# PERMIT

SEWAGE DISPOSAL SYSTEM

OS-371805  
INDEX

SUBDIVISION \_\_\_\_\_ ROAD 7345 Mink Hollow Road LOT \_\_\_\_\_

P 33587

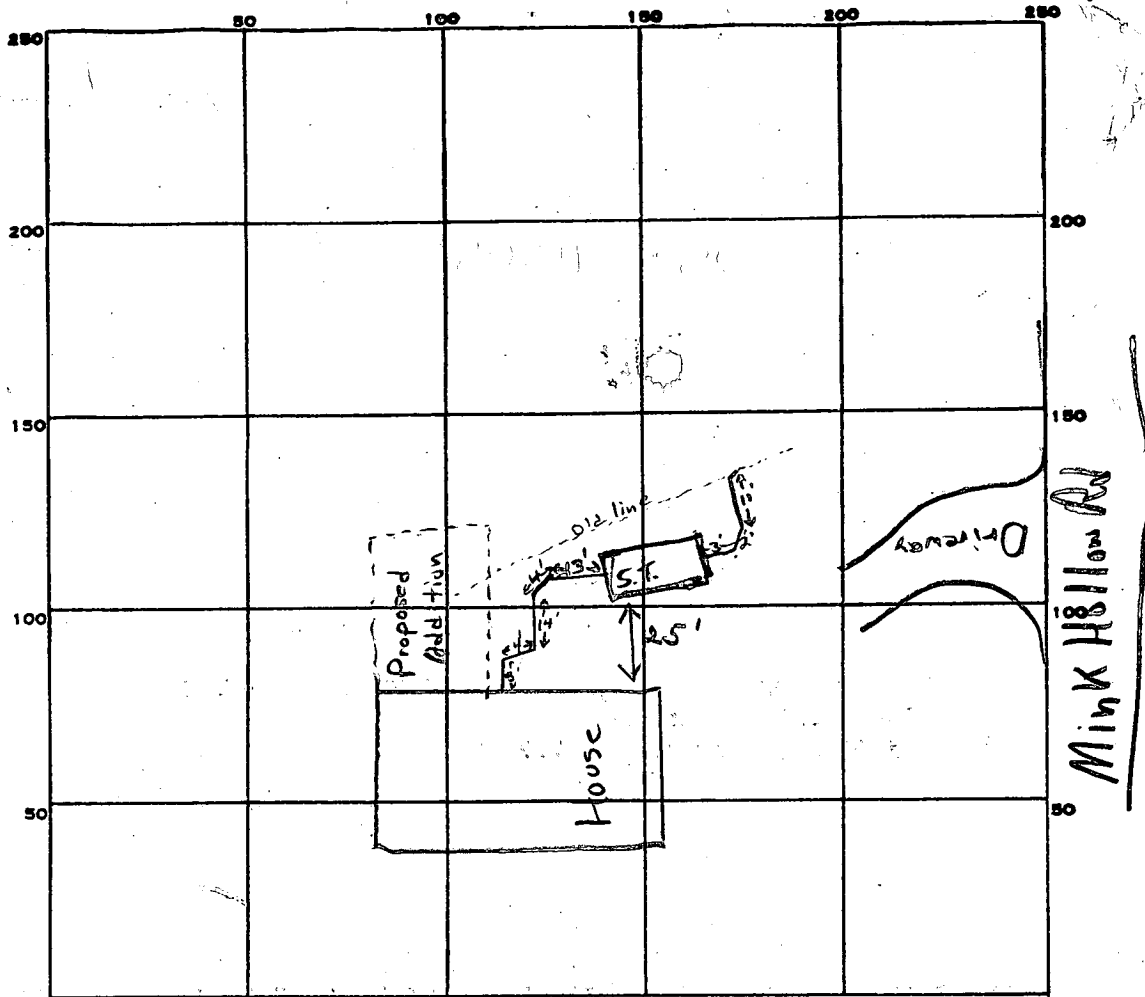
3/22/84 Septic tank in place. Call when

pipe connections are ready for inspection. J

3/28/84 Pipes into & out of septic tank must be cemented to tank. Install cleanout pipe

on septic tank S.T.

CLEANOUT INSTALLED. SYSTEM COMPLETED. 4/12/84 CW

**NOTATION FOR**  
**LARRY GRAHAM**  
 HOLLOW ROAD  
 T, MARYLAND

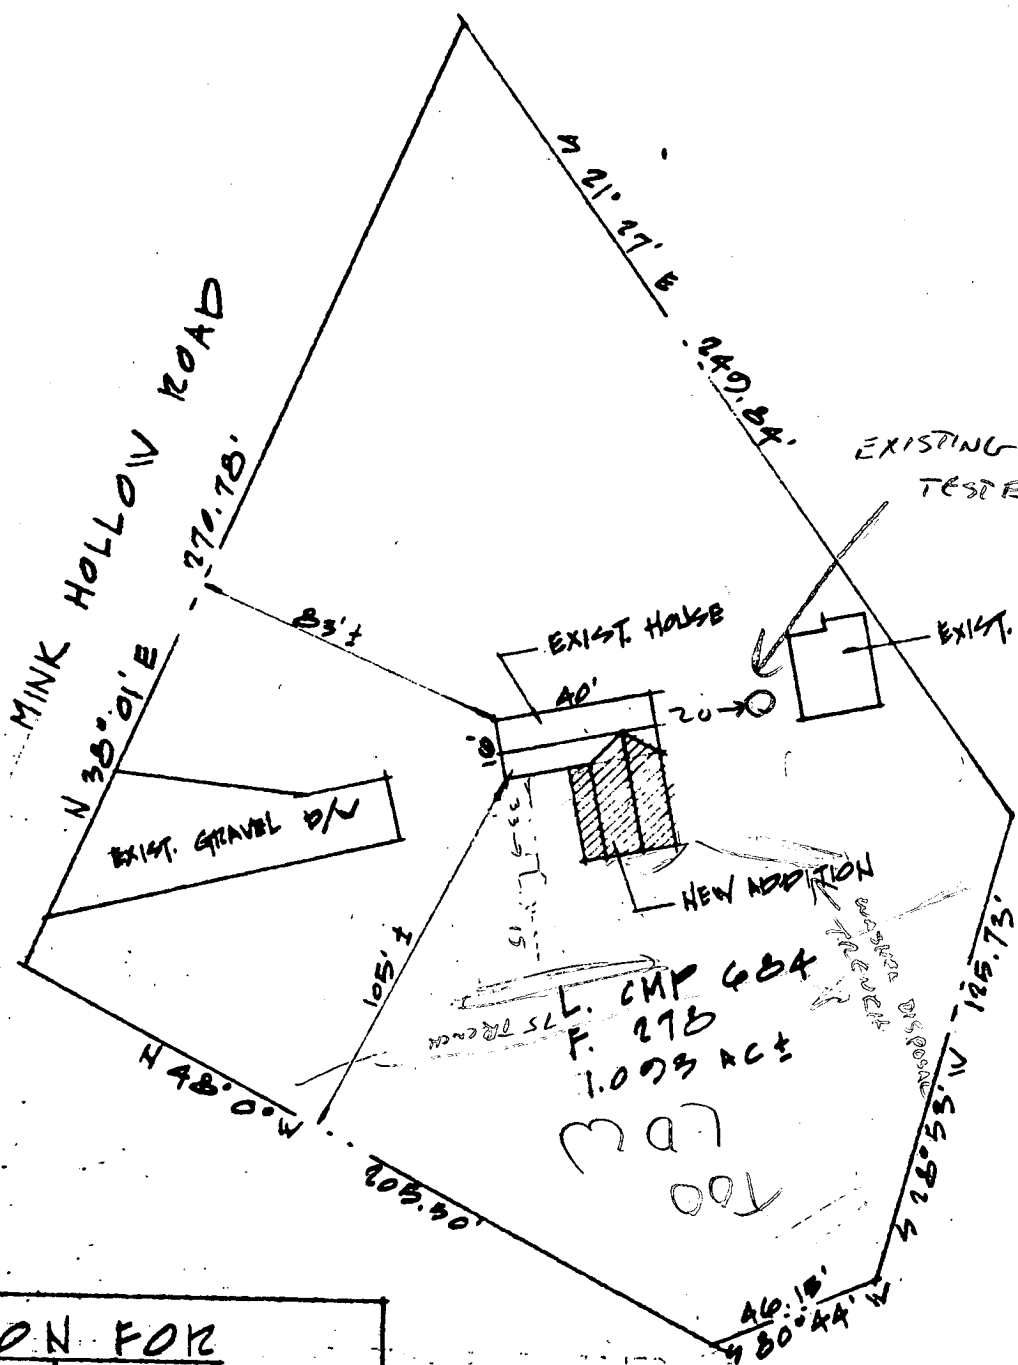
PROPOSE TO  
 RELOCATE (REPLACE)  
 EXISTING TANK  
 CLOSER TO HOUSE  
 TO ALLOW REPAIR  
 TRENCH

EXISTING HAND DUG WELL IN GOOD  
 TESTED CLEAN CONDITION  
 BY COUNTY  
 ON AUG-83'
